Hillsdale Community Health Center
168 South Howell St.
Hillsdale, MI 49242

RE: NRC License No. 21-24813-01

The responses to your request for additional information on August 8, 2012 are in bold.

Close out survey and wipe test

Hot Lab at Dr. Shannon's Office

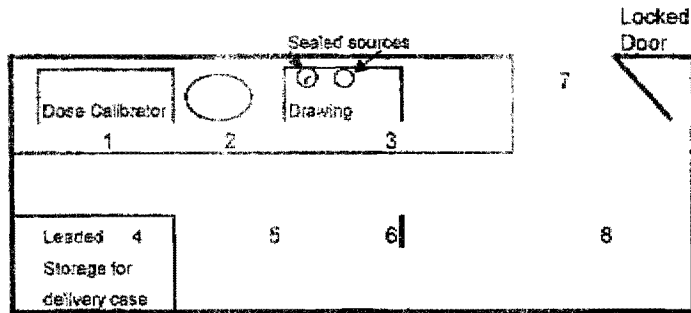
- c. A diagram of your old facility with survey and wipe test results keyed to specific locations. Please record your survey results using the appropriate units as described in 10 CFR 30.36 (j) (2) (i). **See the attachment.**

- 1 Cardiollite doses were the only isotopes used at this site. They were delivered by Syncore and placed on the counter in the locked hot lab by the delivery person.
- 2 Cardiollite doses were administered in the stress lab directly across the hall from the hot lab.
- 3 Used cardiollite doses were returned to the case delivered by Syncore and were stored in the locked hot lab until the next delivery and pick-up from Syncore.

Dr. Shannon's Office 216 Olds Street Jonesville, MI 49250		
Location	Survey (mR/hr)	Wipe (ref dpm/100 cm ²)
1 Dose calibrator counter	<0.02	0
2 Counter top	<0.02	0
3 Sealed source storage	<0.02	0
4 Delivery case storage	<0.02	14
5 Floor	<0.02	0
6 Chair	<0.02	0
7 Door knob and floor	<0.02	0
8 Floor and cabinets	<0.02	3
Background	<0.02	63
